# **London 2012 Olympic Park**

Consolidated Validation Report (Stage 3) -  
Planning Delivery Zone 3

**July 2013**

DRAWING 3 (SHOWING PD23 BOUNDARY)

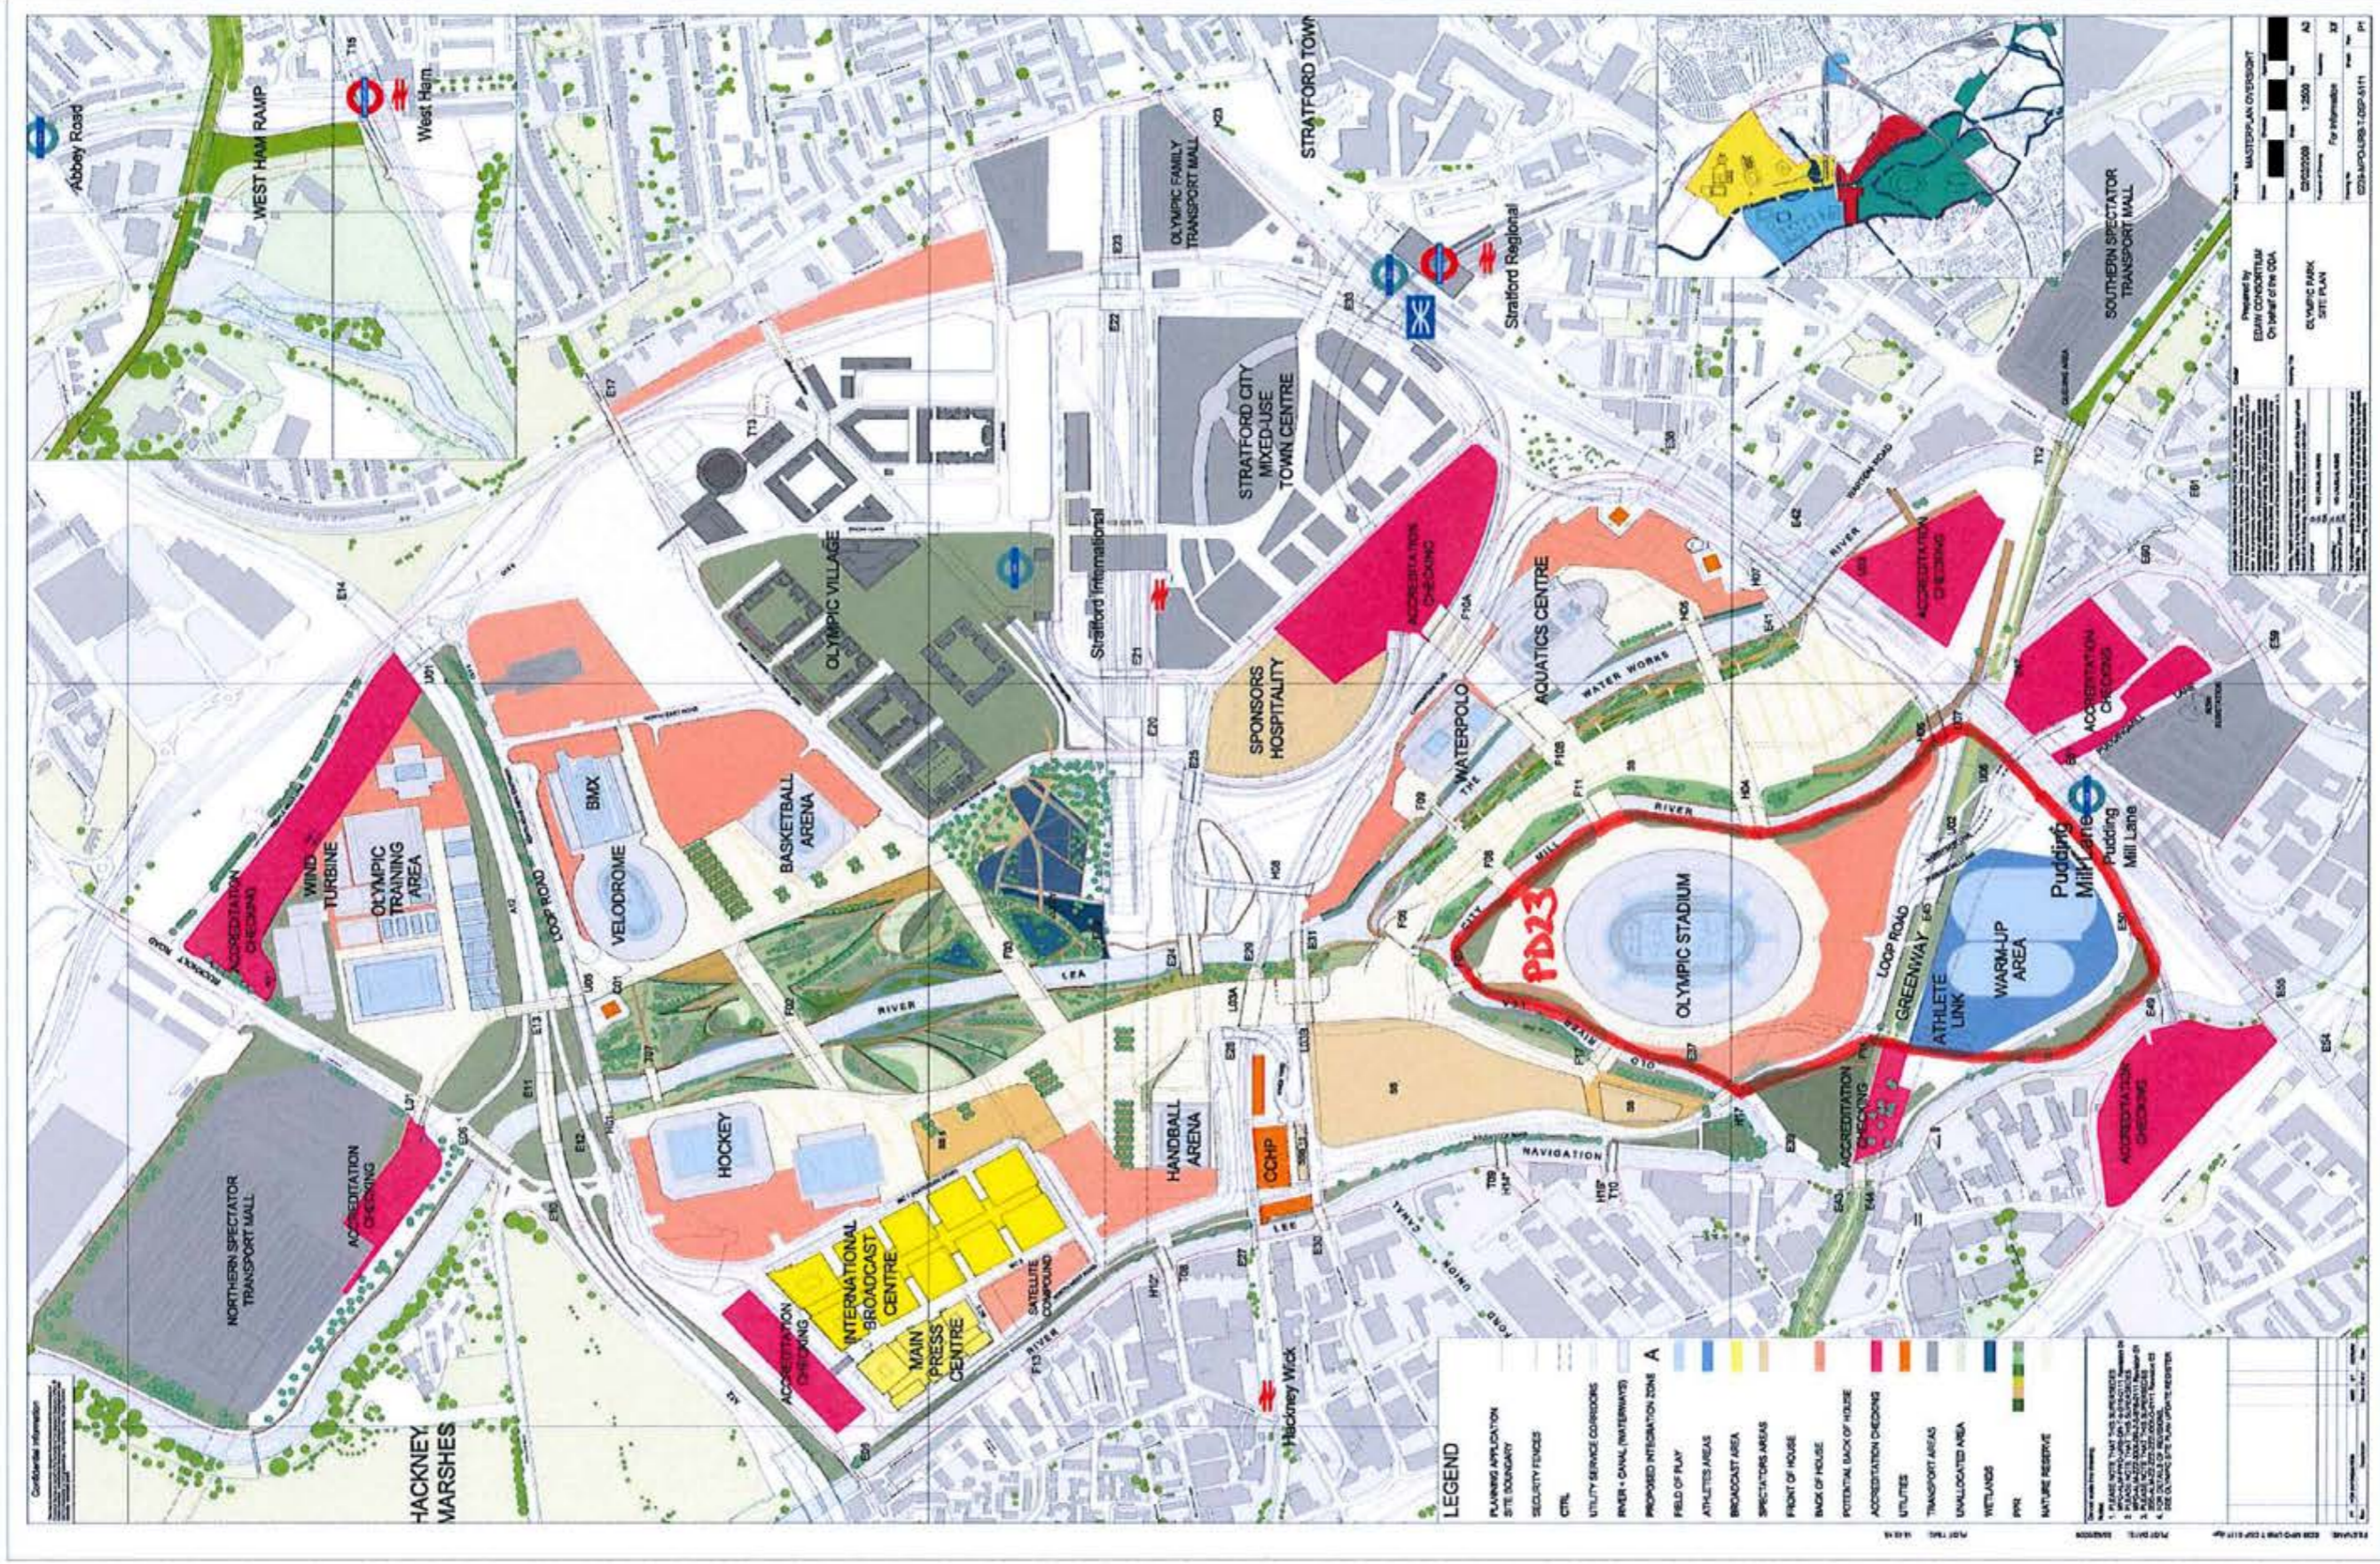
1.2	Drawing 3	<p>Please could you clearly mark up PDZ5 boundary on this drawing – by hand with appropriate legend would suffice.</p> <p>Response 07/06/2013: The PDZ boundary has now been added to this drawing.</p> <p>Hyder review 13/06/13: On the basis that this has been adequately (we have not been provided with the revised drawing, then we have no further comment.</p>

DRAWING NUMBER: **SK-POP-2080**

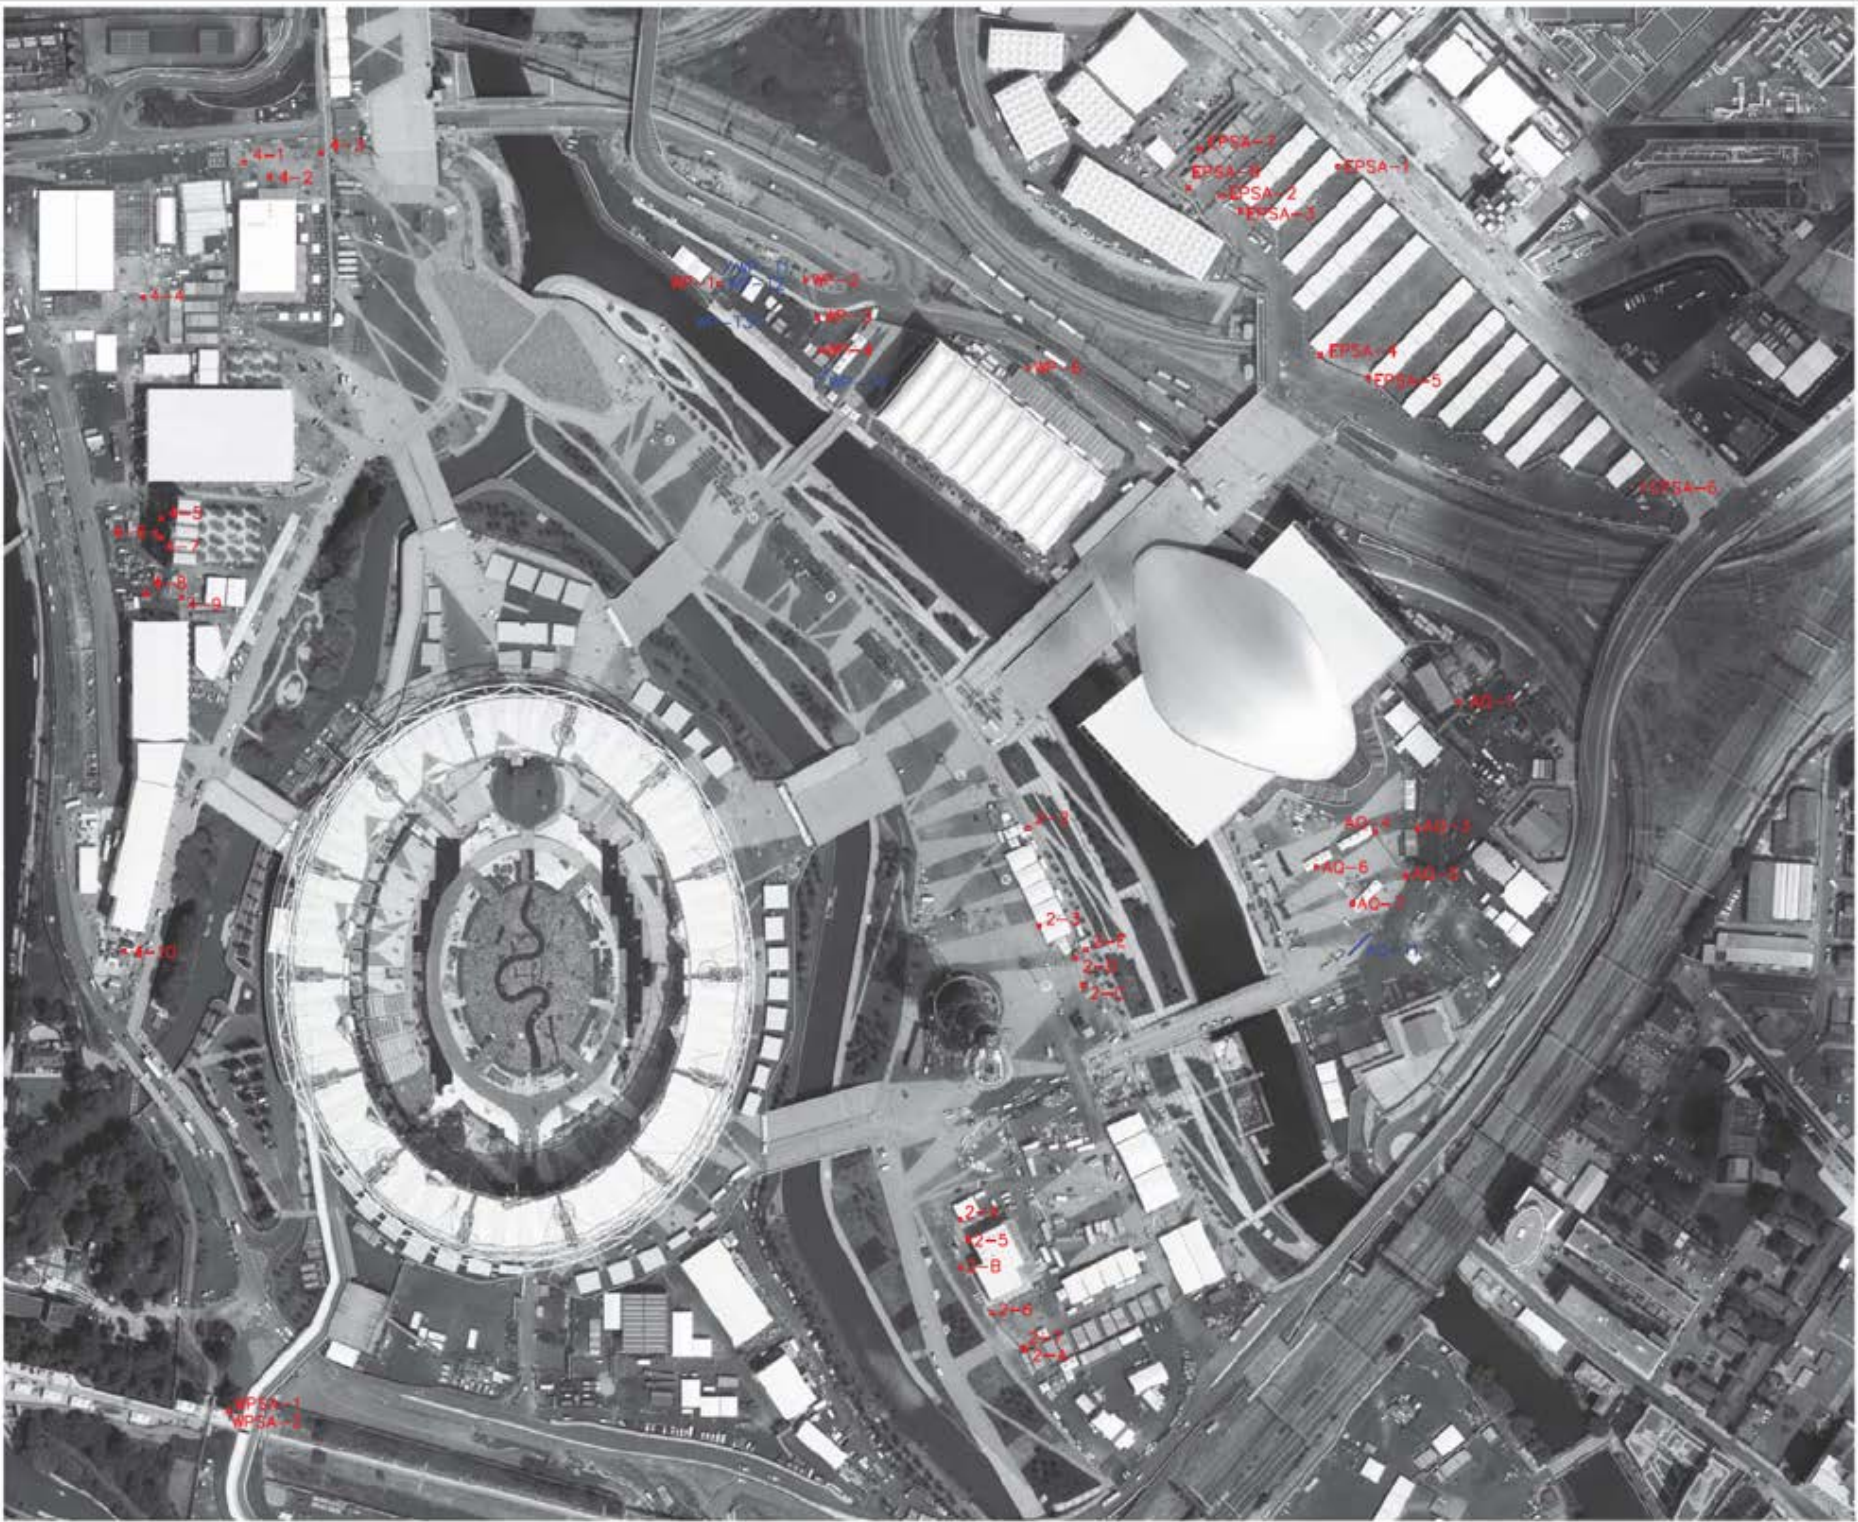
1.3	Drawing 5	<p>This drawing is referred to in Section 3.1.2.3, as showing where 100mm tarmacadam was placed. However it is not immediately clear on Drawing 5 where this was placed. Please can the applicant make hand drawn mark-ups with associated legend to highlight the areas referred to.</p> <p>Response 07/06/2013: This drawing reference has now changed (to Drawing 8) but where referenced an additional note has been added to clarify which area on the drawing is being referred to.</p> <p>Hyder review 13/06/13: No further comment.</p>

DRAWING TITLE  
 POST GAMES LOCOG  
 REINSTATEMENT WORKS  
 SOUTH PARK  
 - SHOWCASE VENUES

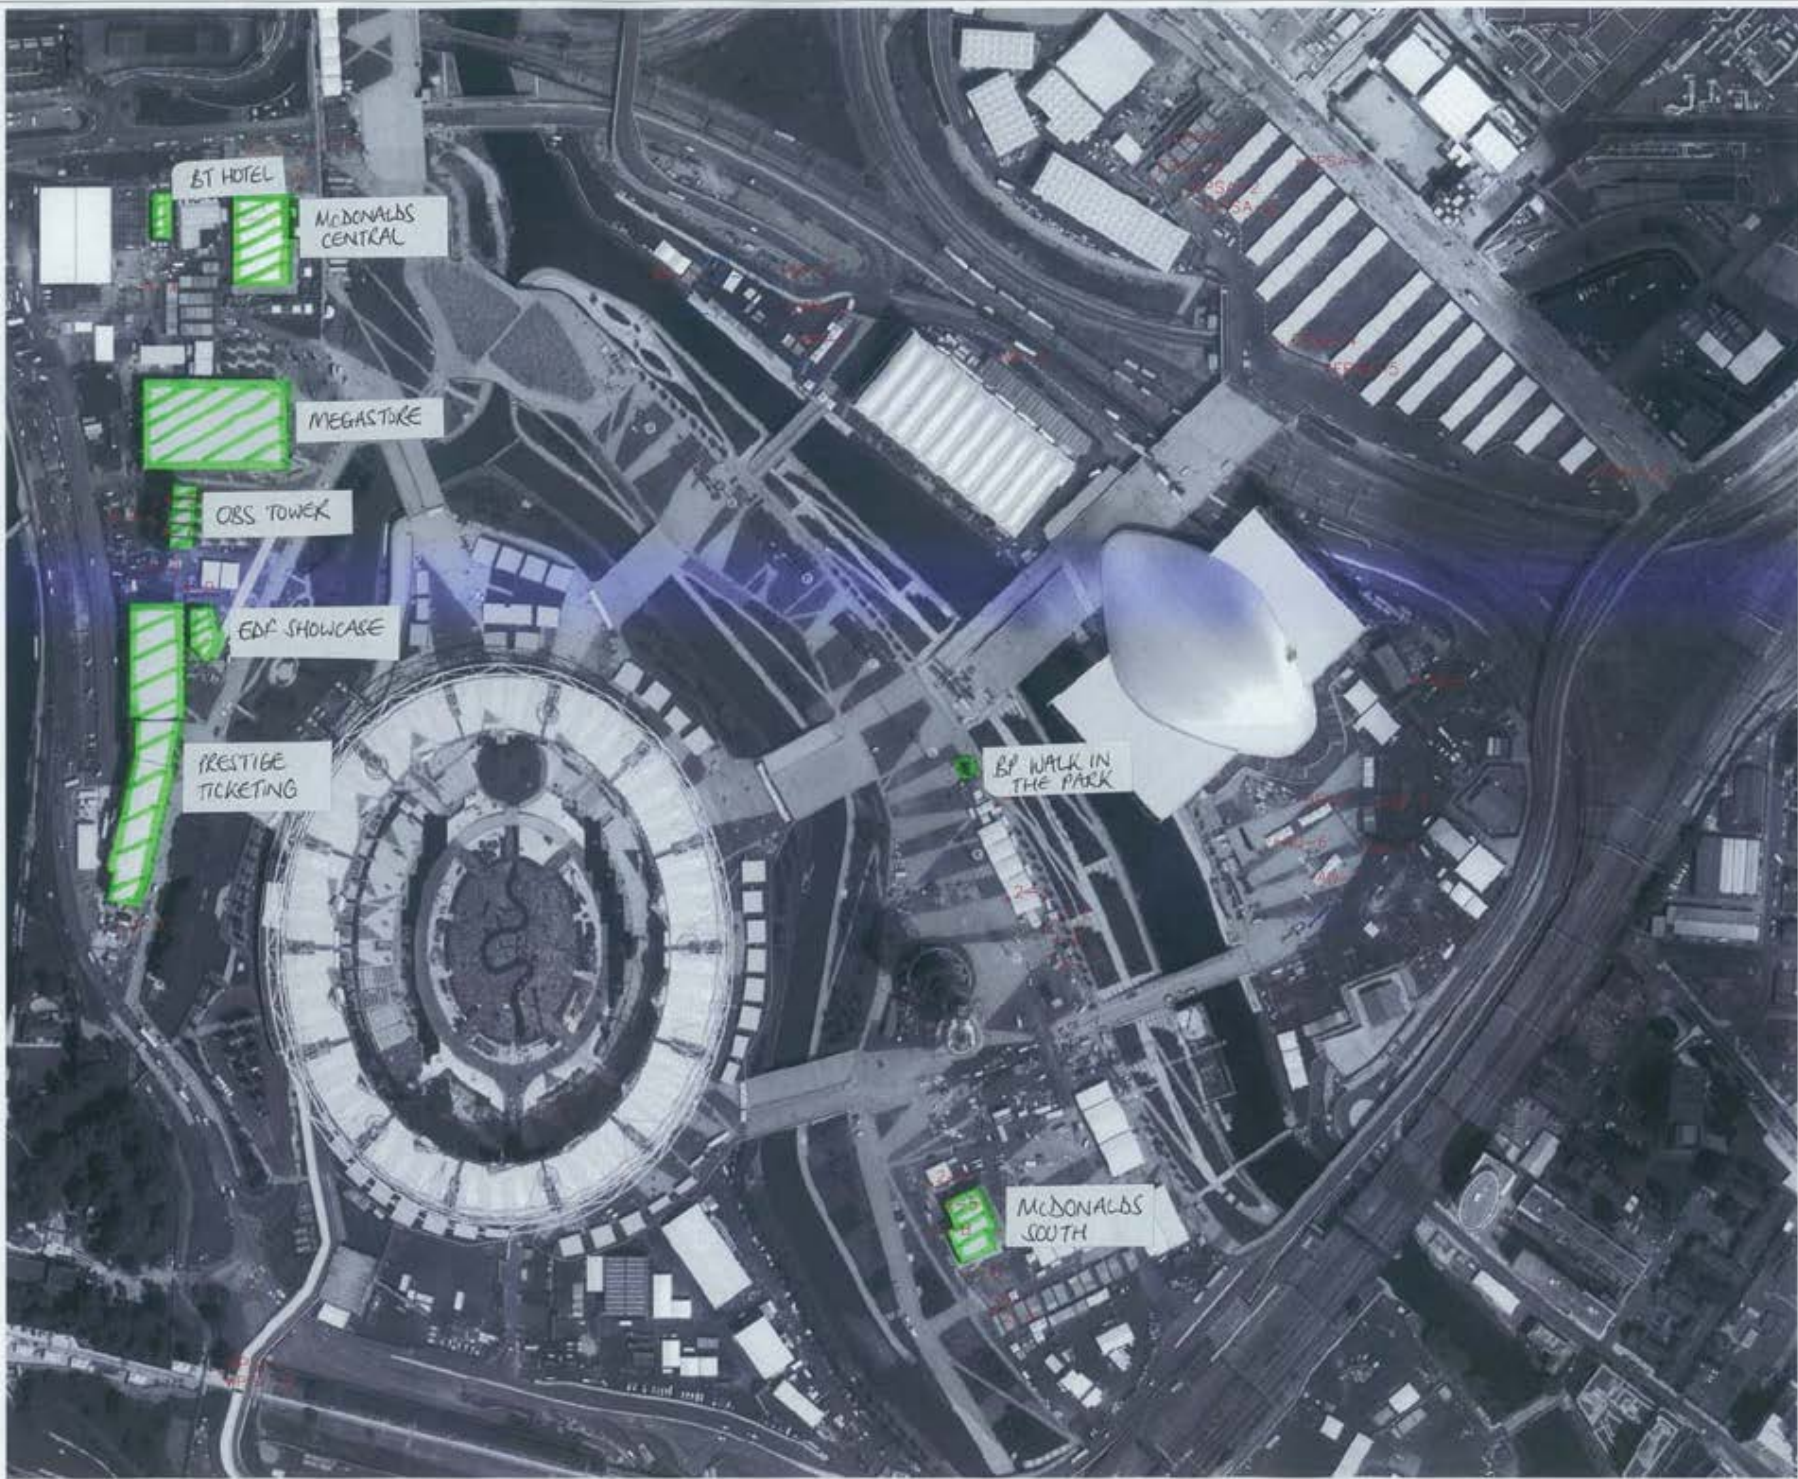
1.4	Drawing 6	<p>This drawing is referred to in Section 3.1.2.3, to show how tarmacadam was placed. Please could the applicant confirm whether as-built drawings are available, which would be more appropriate.</p> <p>Response 07/06/2013: This drawing is now referenced as Drawing 9. Unfortunately no further as-built information is available from the project to support close out of the CVR.</p> <p>Hyder review 13/06/13: No further comment.</p>
